APPLICATION NO.	FILING DATE	FIRST NAMED INVENTOR	ATTORNEY DOCKET NO.	CONFIRMATION NO.
10/593,978	09/22/2006	Hayato Yoshino	1018773-000046	3260
21839 7590 11/14/2008 BUCHANAN, INGERSOLL & ROONEY PC POST OFFICE BOX 1404 ALEXANDRIA, VA 22313-1404				
EXAMINER DESAL, NAISHADH N				
ART UNIT 2834		PAPER NUMBER		
NOTIFICATION DATE 11/14/2008		DELIVERY MODE ELECTRONIC

Office Action Summary

DETAILED ACTION

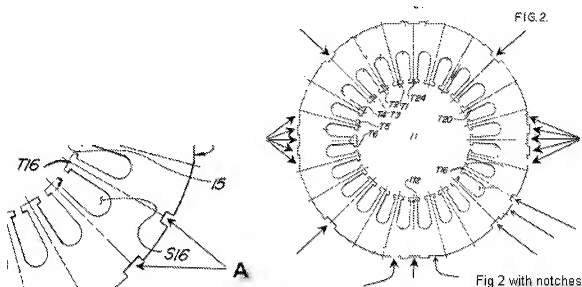
at least five notches each notch formed by a single uninterrupted roughly straight line on an outer circumference edge of the stator iron core (re-illustrations of Fig 2 and close up of portion 3 by examiner below), so that a quadrangle is formed by straight lines including four notches out of the at least five notches (Fig 2 below with arrows shows that a quadrangle can be drawn if straight lines are drawn from the notches).

Regarding applicant's argument that portions 1,2,4 and 6 are not teaching roughly straight lines in relation to Fig 2 of Landgraf. Examiner believes Fig 2 and portions 1,2,4 and 6 do show "...a single uninterrupted roughly straight line...". They do include other portions which have tabs which protrude from the outer circumference edge of the core, yet they also contain smaller portions of uninterrupted straight lines. Examiner would like to remind applicant that a slight curvature on a line can be considered as a "roughly straight line". Cited prior art by examiner read on the claims as presented by applicant. Applicant's arguments are found non persuasive by examiner.

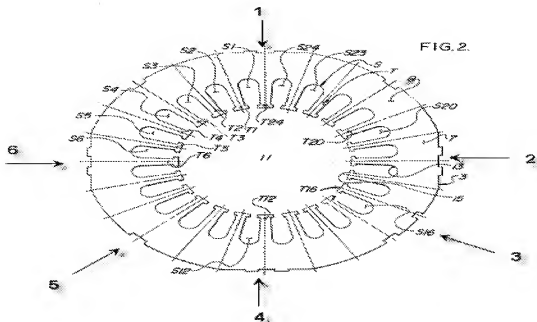
The single-phase motor of claim 1, wherein the single-phase motor comprises six notches, so that a rectangle or a square is formed by straight lines including four notches out of the six notches (Fig 2,1-6 below and Fig 2, arrows above shows that several straight lines can be drawn on an outer circumference of the stator to form a rectangle or square out of 4 lines).

a plurality of evenly spaced semicircular notches having an approximately same width as the stator teeth and each provided at an outer side of each of the plurality of stator teeth on an outer circumference of the stator iron core (Fig 2,5 above).

Landgraf does not literally teach that that there are "a plurality of evenly spaced semicircular notches having an approximately same width as the stator teeth and each provided at an outer side of each of the plurality of stator teeth on an outer circumference of the stator iron core". However, examiner notes that Fig 2,5 above of

Landgraf appears to teach a plurality of semicircular notches, However perhaps not inherently uniformly distributed or evenly spaced.
